RFP 23MCO617

In response refer to RFP No. 23MCO617 Addendum 2 and Response to Questions November 14, 2023

PROJECT: Reconstruction of County Road 1054 from Martin County Line to FM 30.

**PLAN AND PROFILE
STA 0+00 TO 11+00**

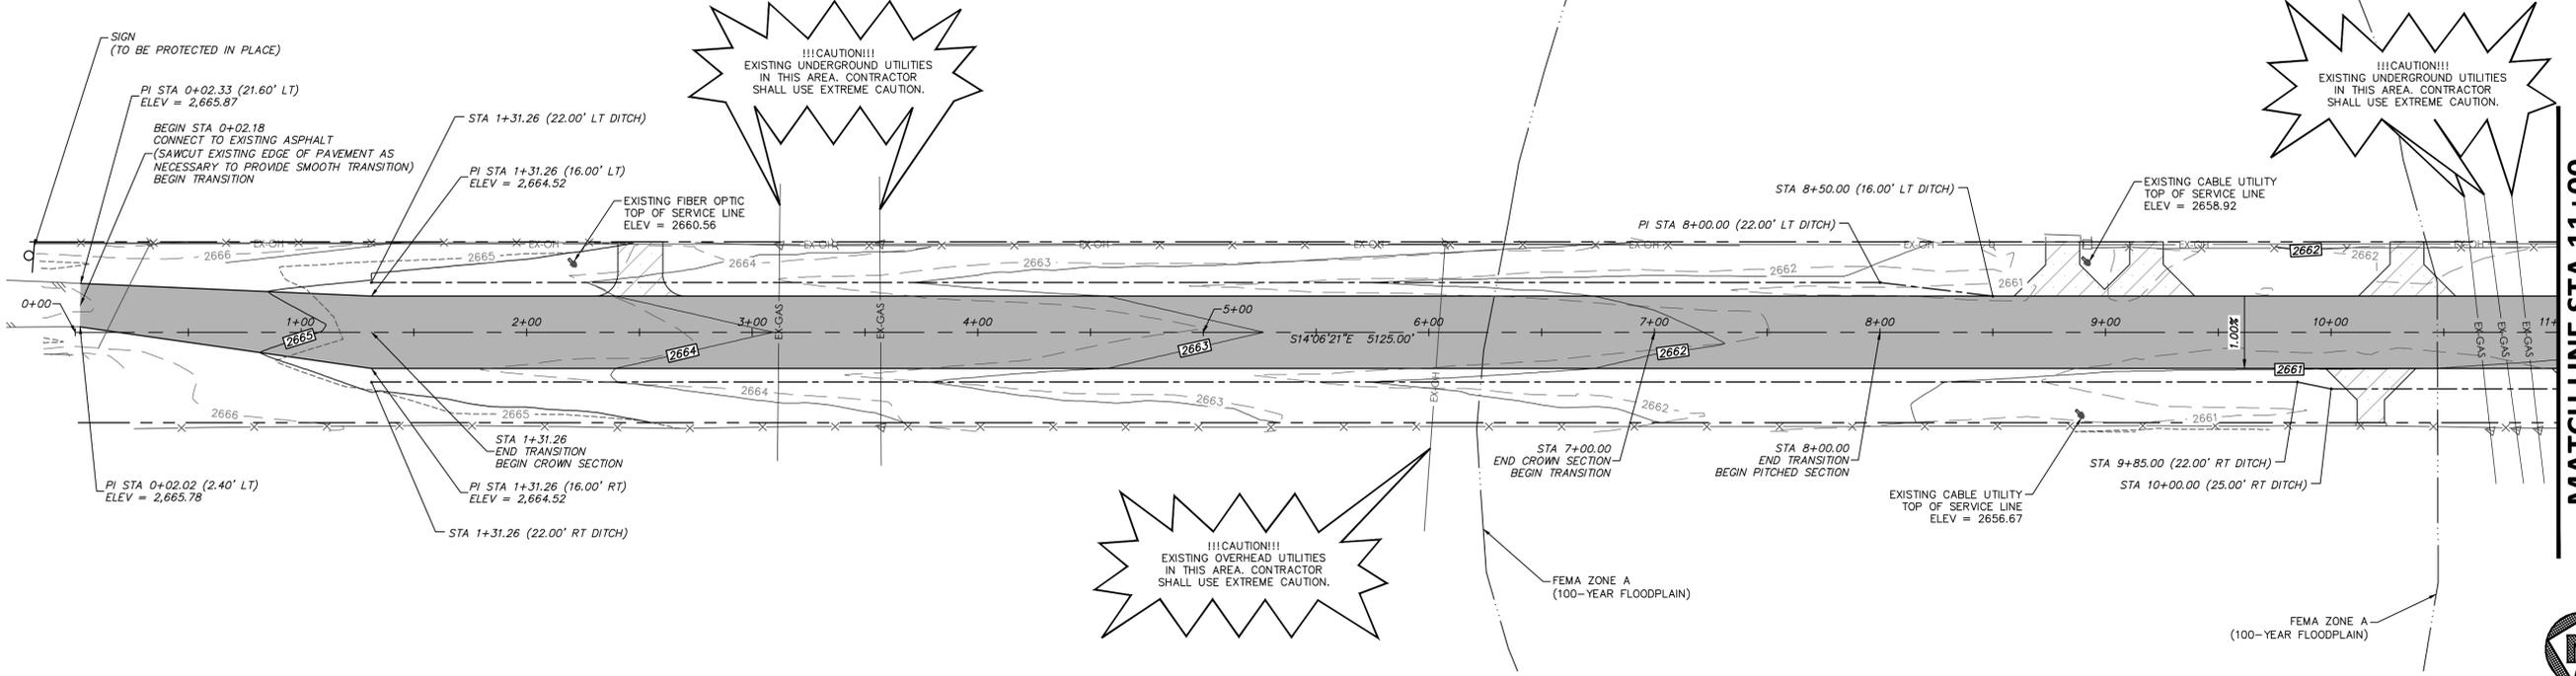
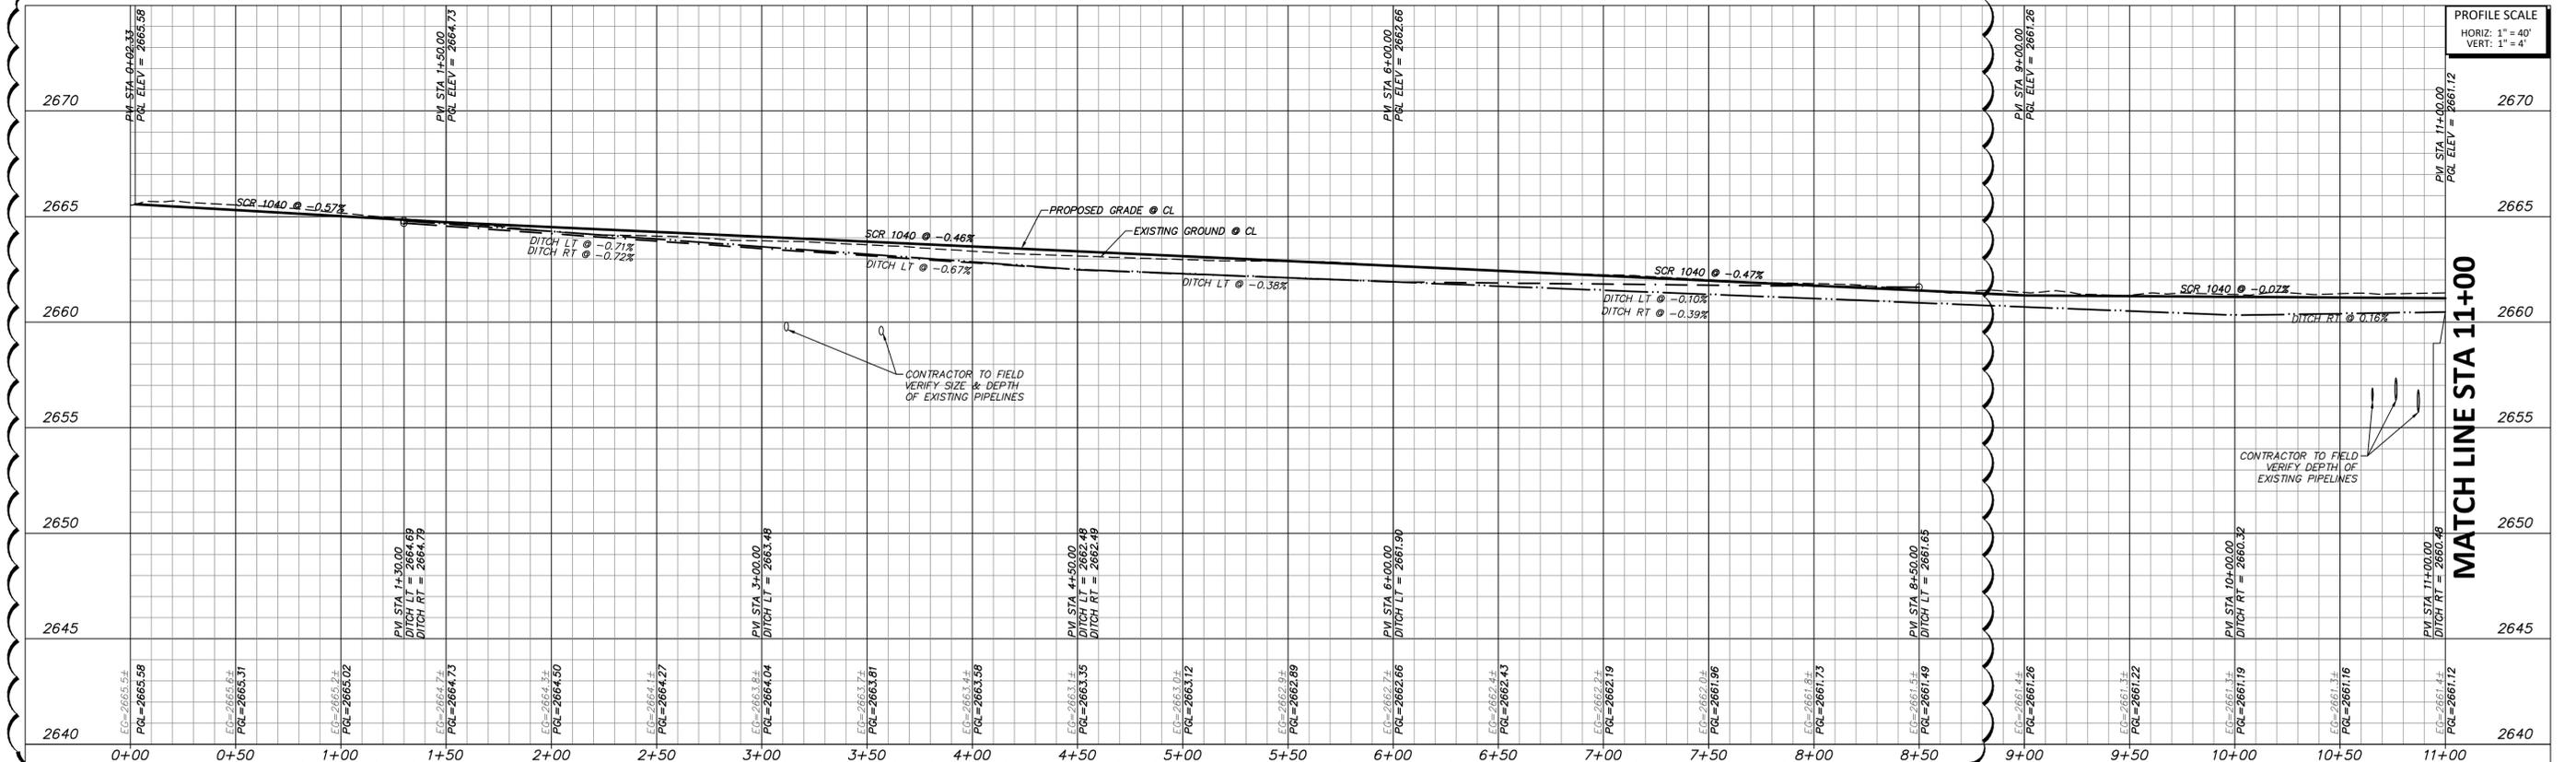
2. Station 8+50 L. Proposed EOP grade where bar ditch ties into EOP is 61.49. Center line grade is also 61.49. Is this correct??
Please see revised sheets for ditch revisions.

NO.	REVISION	BY	DATE	CHECKED
1	LEFT DITCH REVISION STA 1+30 - STA 8+50	RLB	11/13/2023	AJA
				DESIGNED
				RVG
				DRAWN
				BWA
